19 April 2023
30552.9082

Response to s92 requests - Point Erin Tunnel

Further to your letter dated 28 March 2023 requesting further information with respect to application BUN60415108, we provide the below response.

Appendix C Noise and vibration – tree chipping

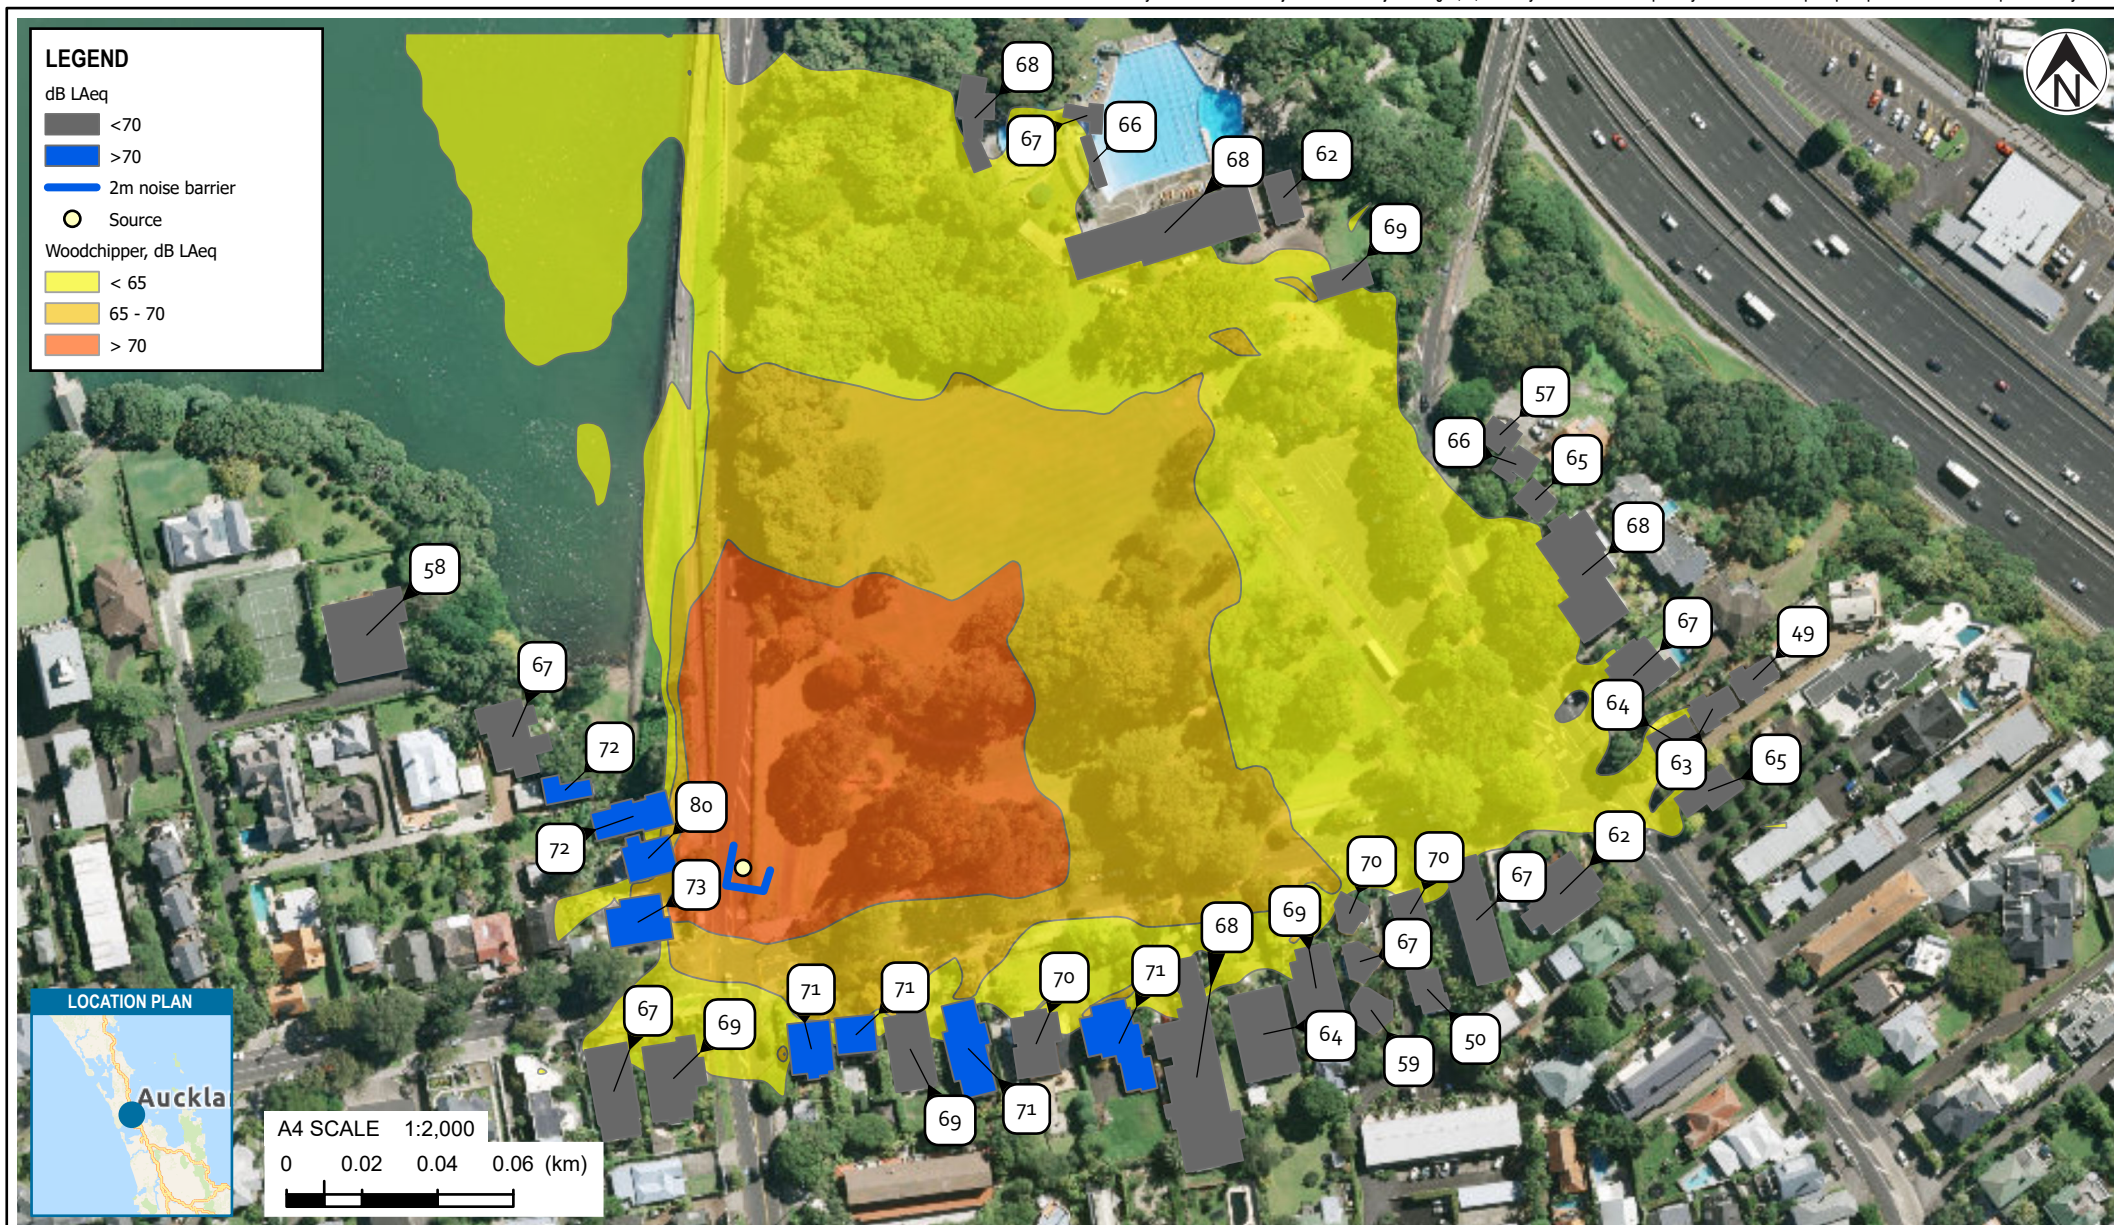
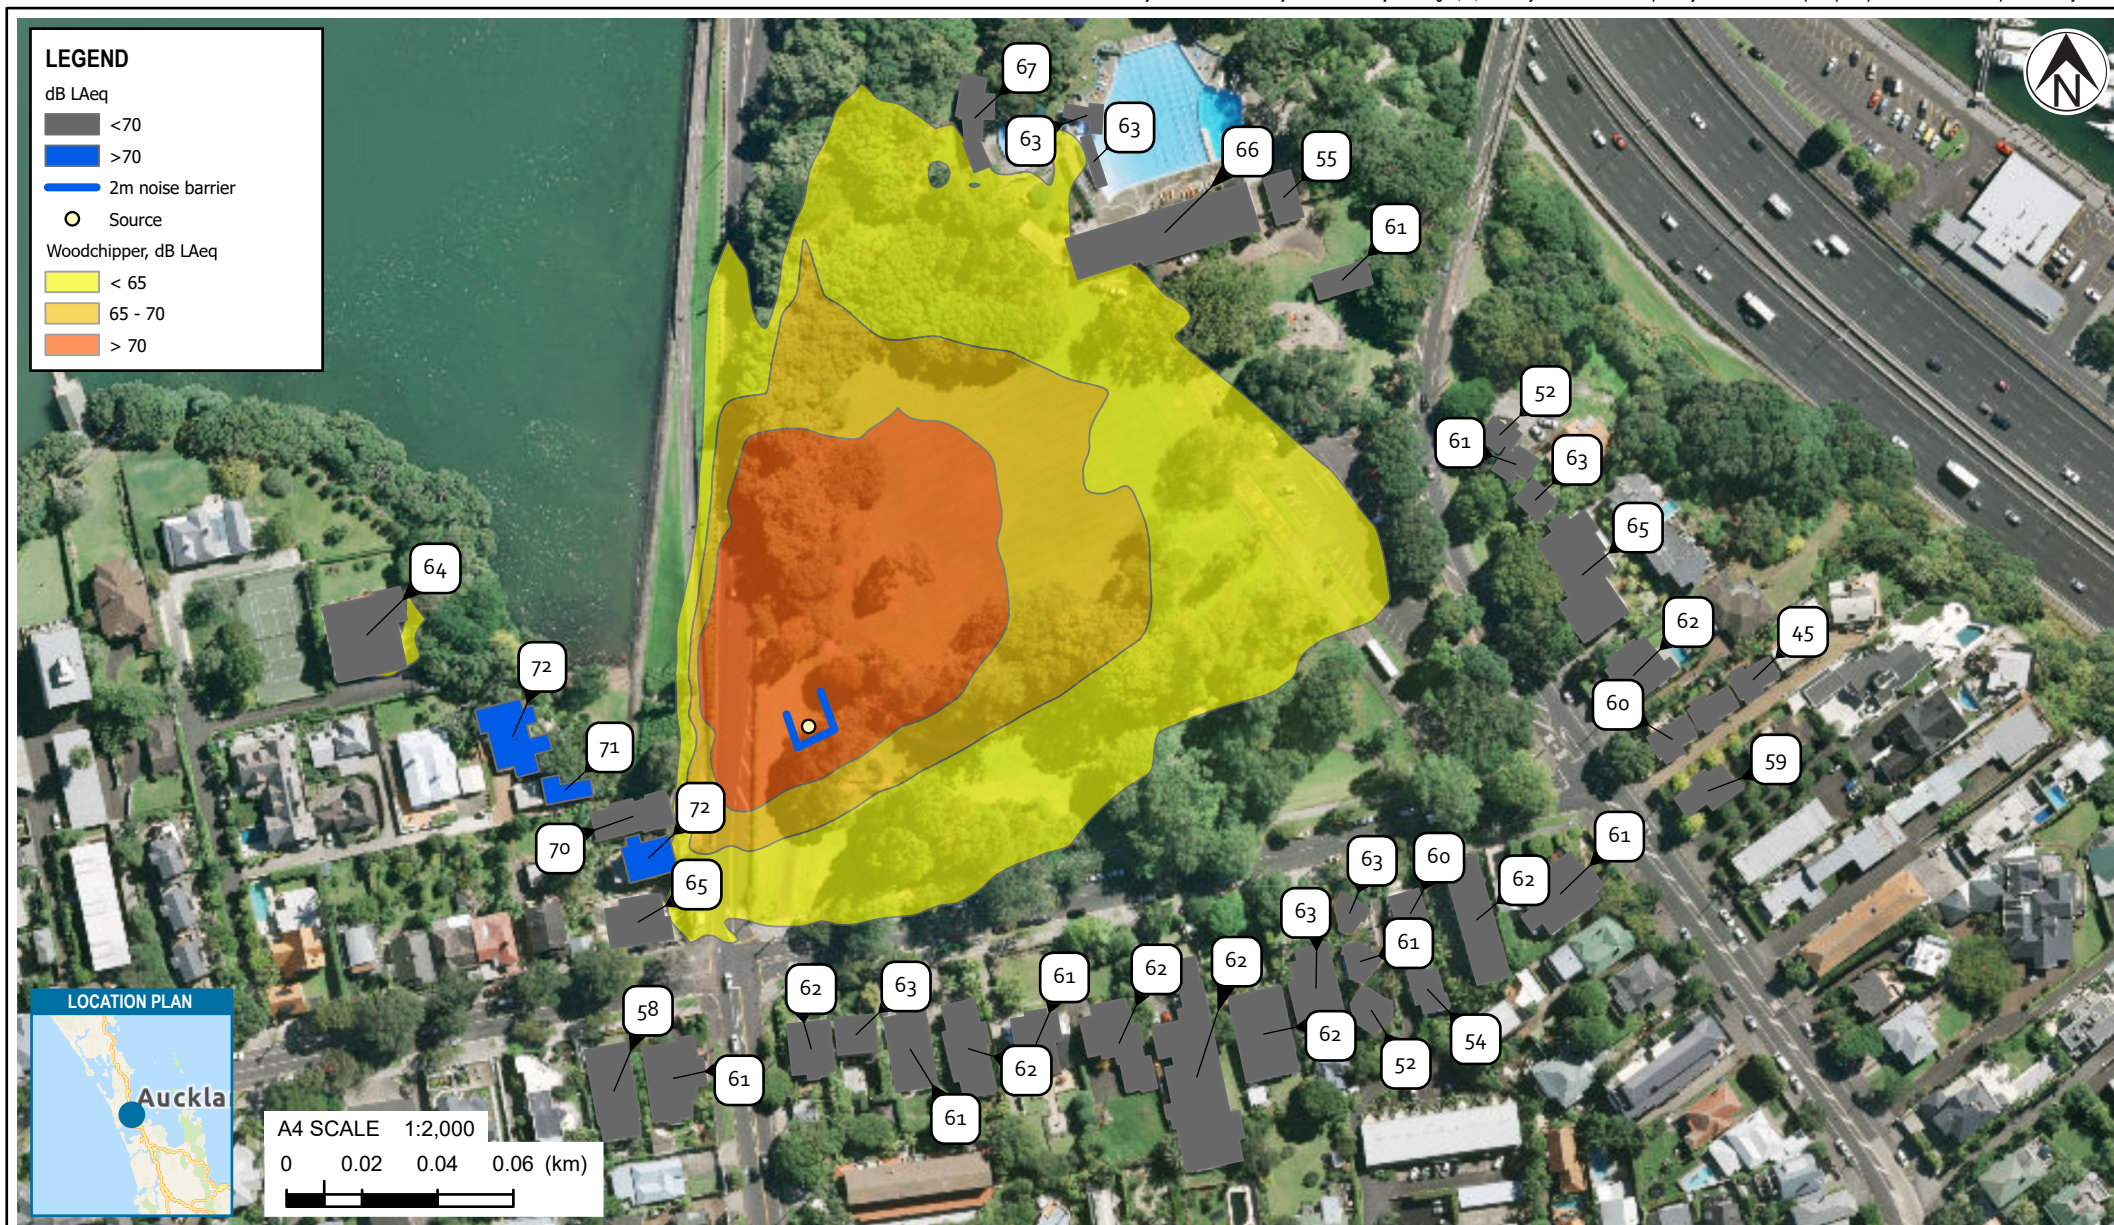
- 40 *What are the predicted noise levels, and the timing and duration of any expected noise compliances, during tree removal and chipping on site, including all proposed mitigation measures? This information is required to understand the level of effect that an Activity Specific Noise and Vibration Management Plan for these activities would enable.*

Tree removal works are likely to be completed within a five day period during normal construction hours. The woodchipper will be operated periodically over this time. Currently, it has not been determined where the woodchipper will be located, therefore two approximate locations have been assumed to provide a worst case prediction (Figure A1) and more likely location (Figure A2) (Appendix C). The woodchipper may not be limited to the two locations only, and the presented noise levels are indicative. Predictions will be revised prior to tree removal activities as part of the activity specific management within the CNVMP. Predictions assume a 2 m noise barrier will be erected around the woodchipper.

- An activity specific management plan/section within the CNVMP to be submitted to Council prior to commencement of the activity to identify location of works and affected parties;
- A 2-3 m barrier will be erected around the woodchipper;
- Consultation with affected parties to enable scheduling of works outside of sensitive times during normal construction hours;
- Noise monitoring when wood chipping commences.

Appendix D Updated vehicle tracking drawings

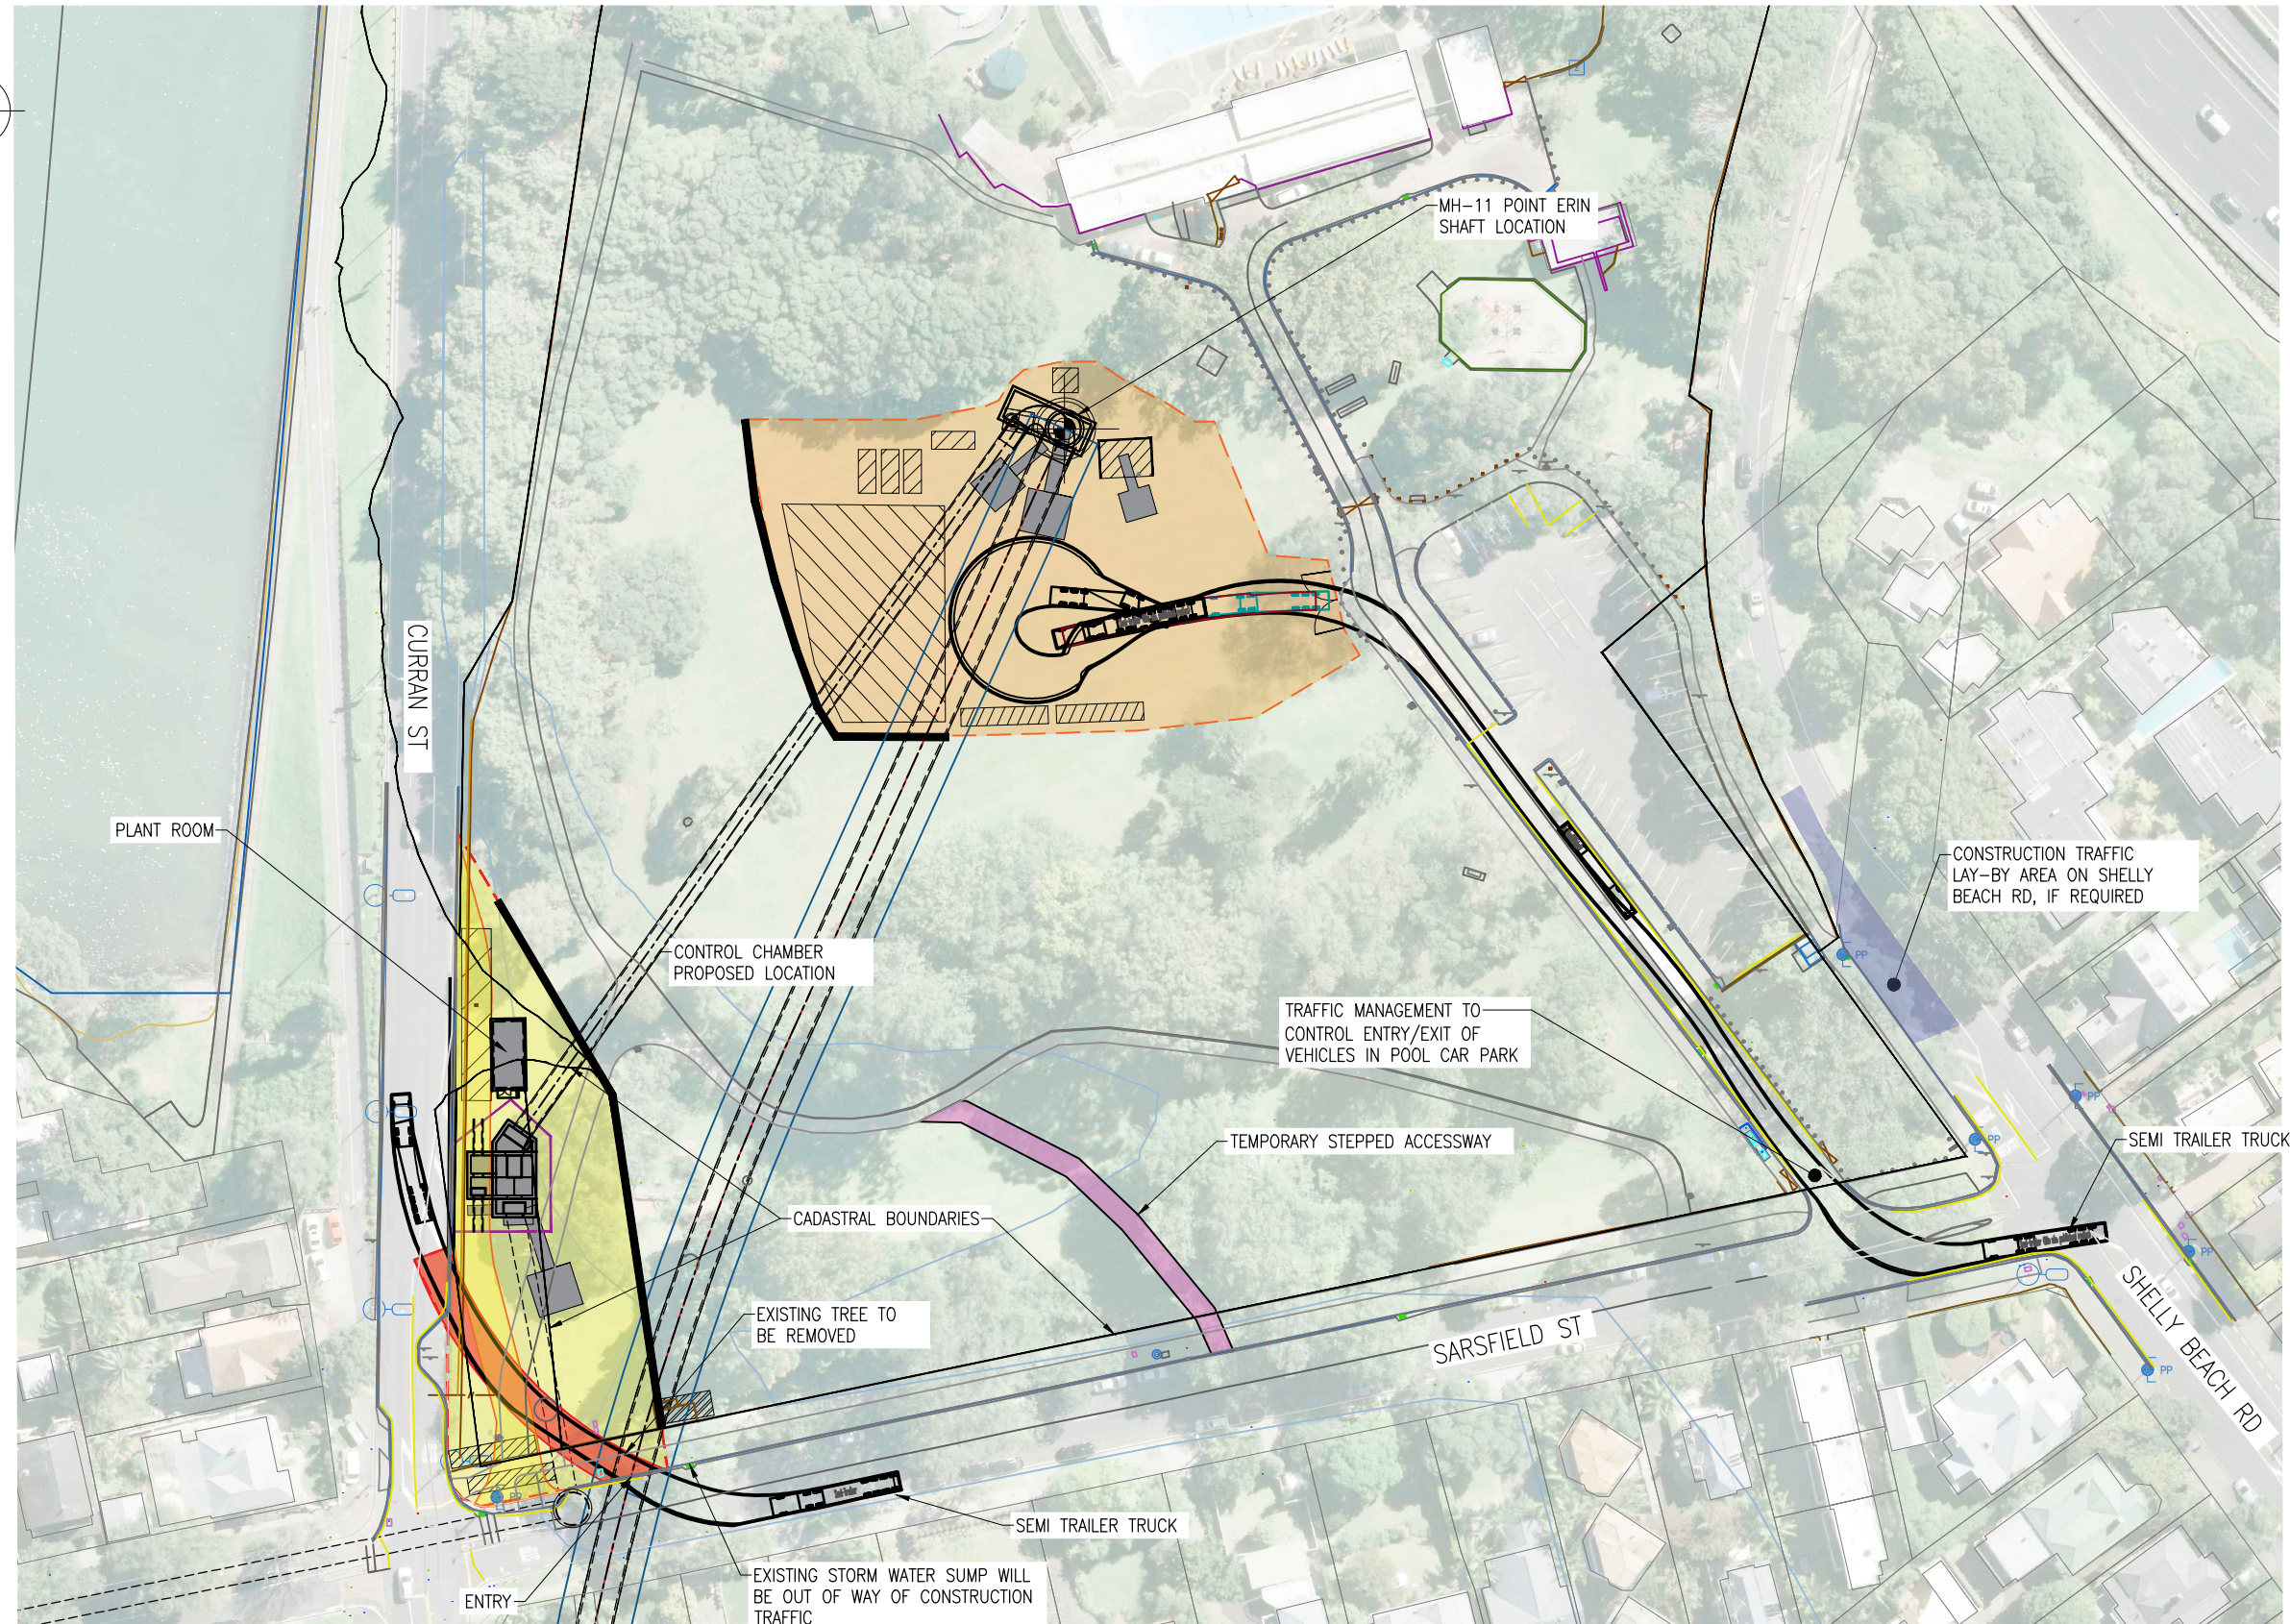
- 45 *The vehicle crossing drawing for the Sarsfield Road access as shown on Appendix B – “Drawings, Proposed Site Layout” indicates that an existing power and lighting pole will be located in the middle of the proposed permanent vehicle crossing along with an existing catch pit. The vehicle crossing also splays towards the west. Noting the above, please provide:*
- a *an assessment of the vehicle crossing’s design in relation to the power pole, noting the ITA appears to indicate tracking those conflicts with the pole.*

An updated drawing of the south west permanent access is attached in Appendix D with vehicle tracking (drawing No. 2013964.010). Please note the following:

- The existing street tree will be removed (provision for its removal is included in the resource consent application).
 - The existing power pole will not be affected and hence no change is required.
